Erin Engman
Associate Planner
City of Tualatin
18880 SW Martinazzi Avenue
Tualatin, Oregon 97062

**Re: Herman Road Industrial
Tax Lot I.D: 2S123BA2900, 3100, 2S123B0900**

Thank you for the opportunity to review the proposed site plan surrounding the above-named development project. These notes are provided regarding the plans received October 28, 2020 and are based on the current New Construction Guide. There may be more or less requirements needed based upon the final project design, however, Tualatin Valley Fire & Rescue will endorse this proposal predicated on the following criteria and conditions of approval.

Fire Hydrants

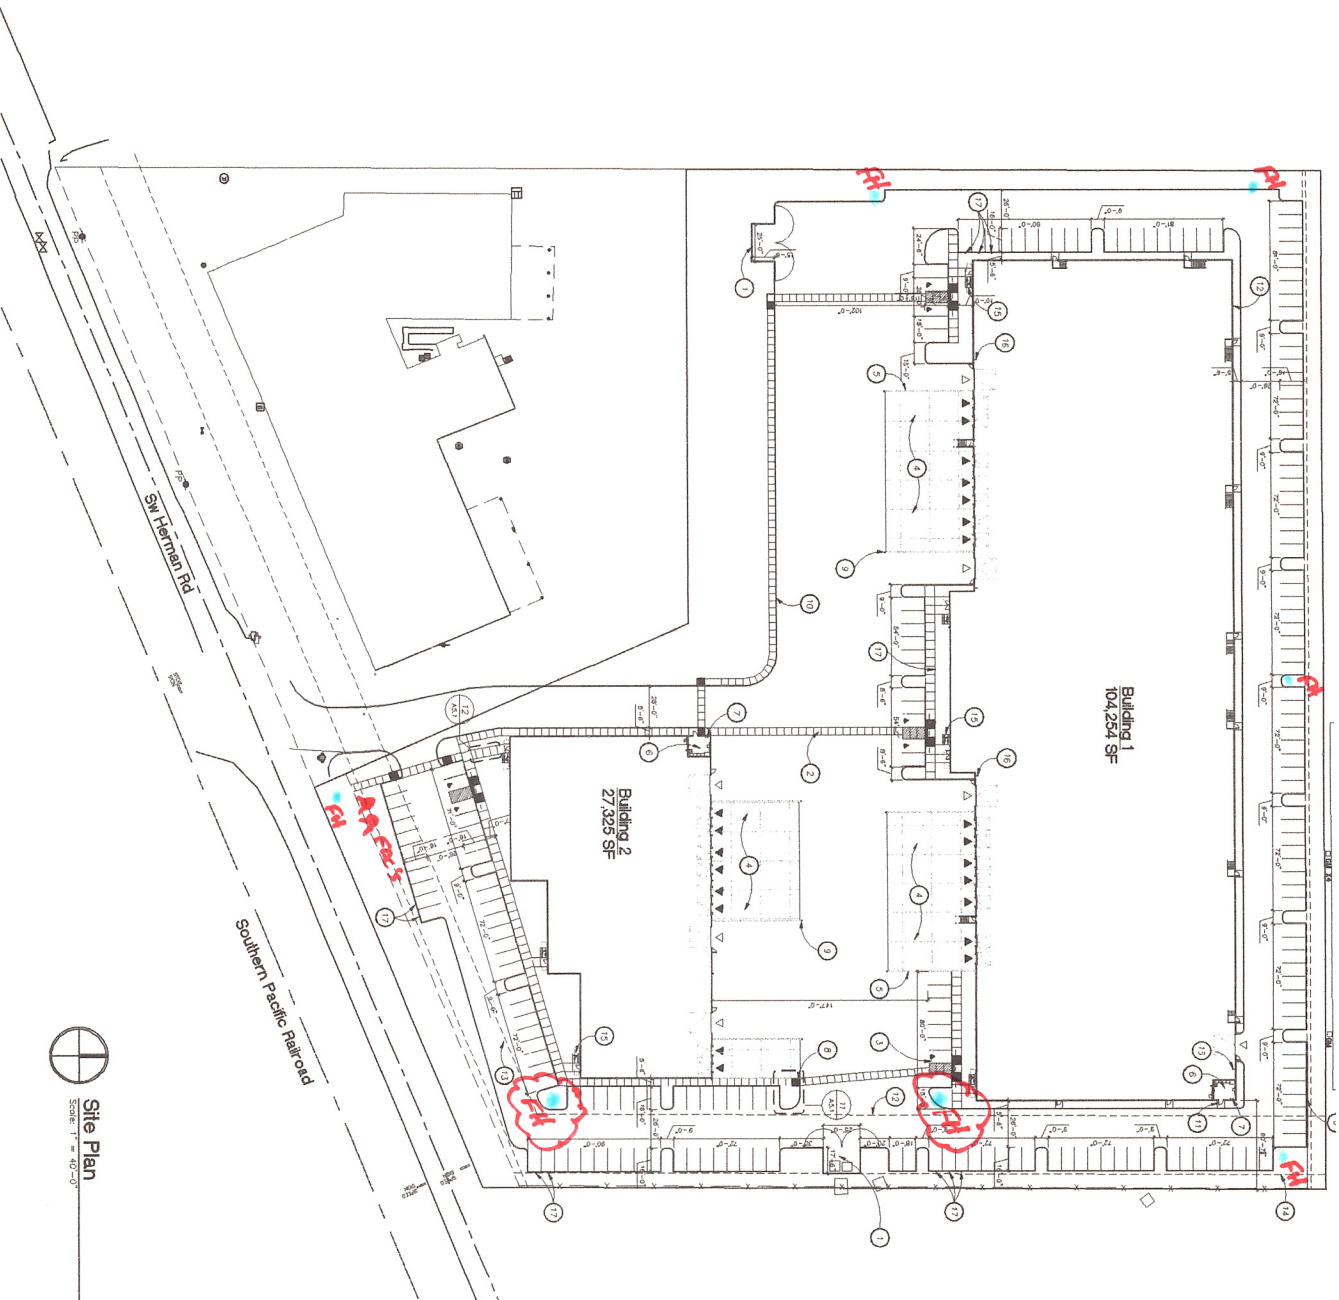
See attached sheet for required fire flow. Fire sprinkler demand must be added to this requirement.

See attached sheet for locations of fire hydrants. Note two additional hydrants.

BUDE 1:
104,254 ft² = 6,750 GPM
75% Reduction = 1,688 GPM

BUDE 2:
27,325 ft² = 3,500 GPM
75% Reduction = 1,500 GPM

FIRE LANES

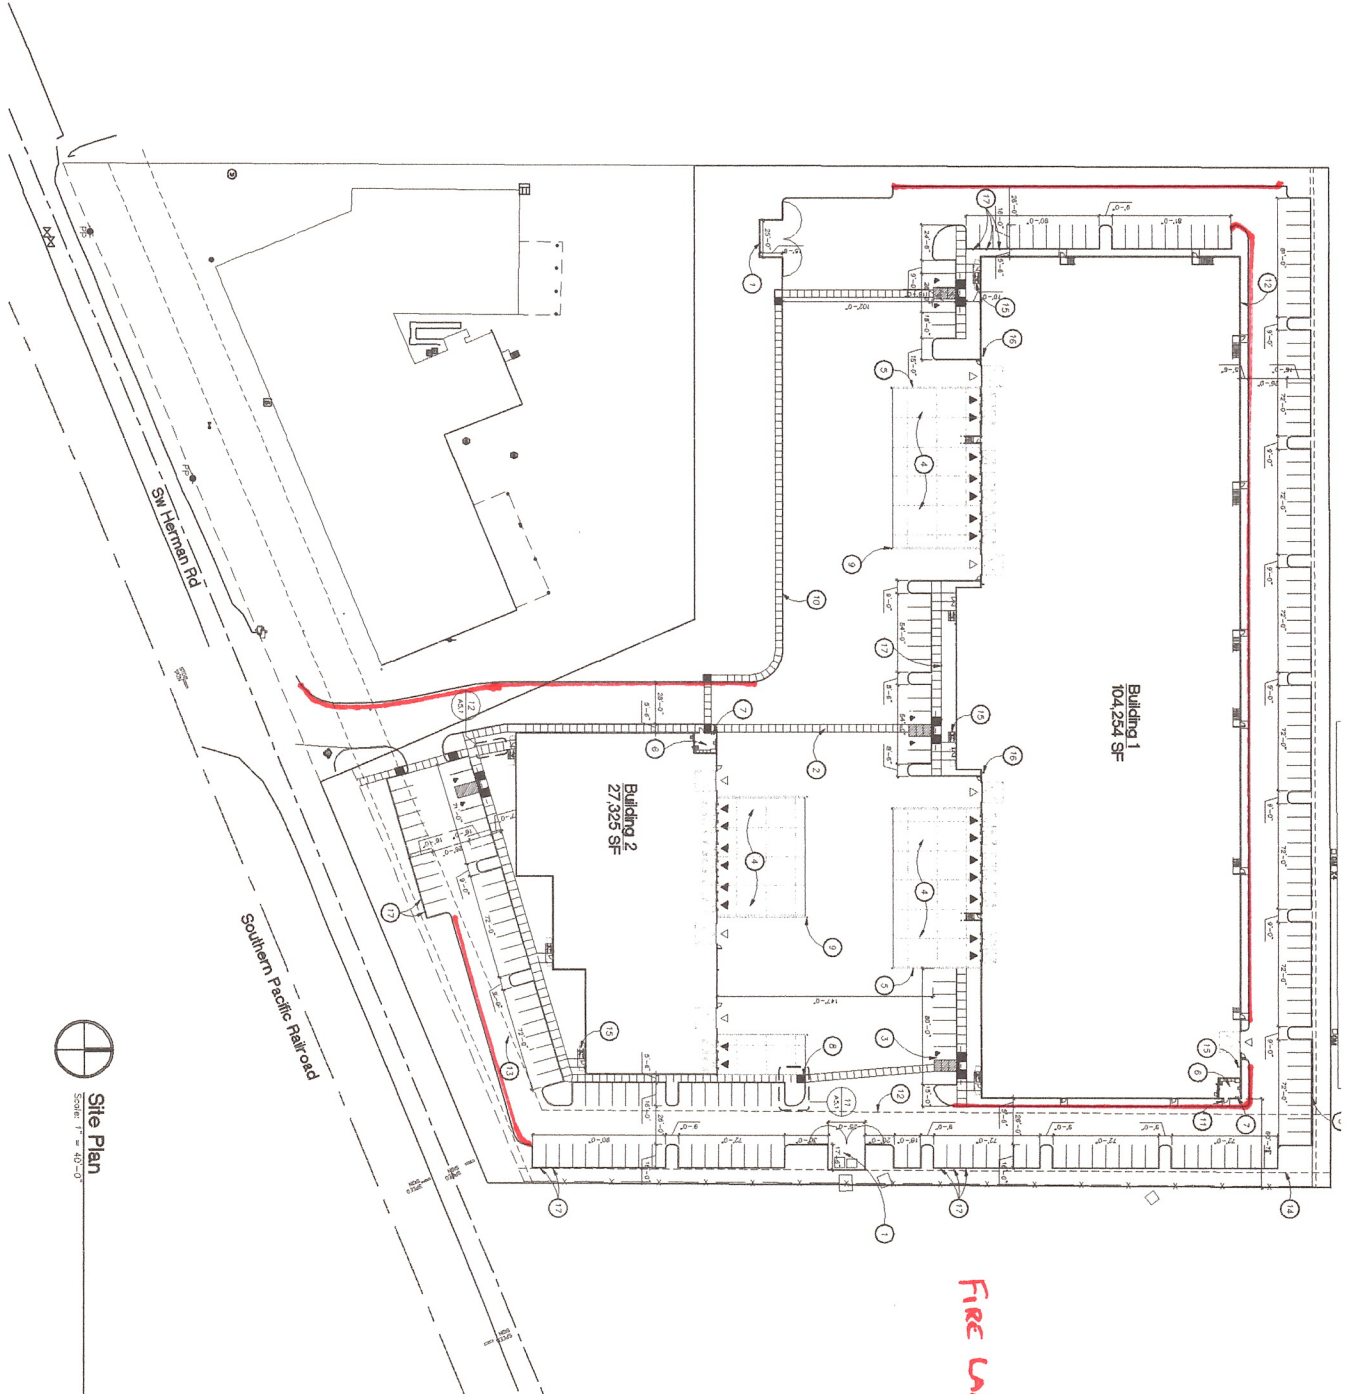
See attached sheet for locations of fire lanes.

See attached sheet for locations of fire lanes.
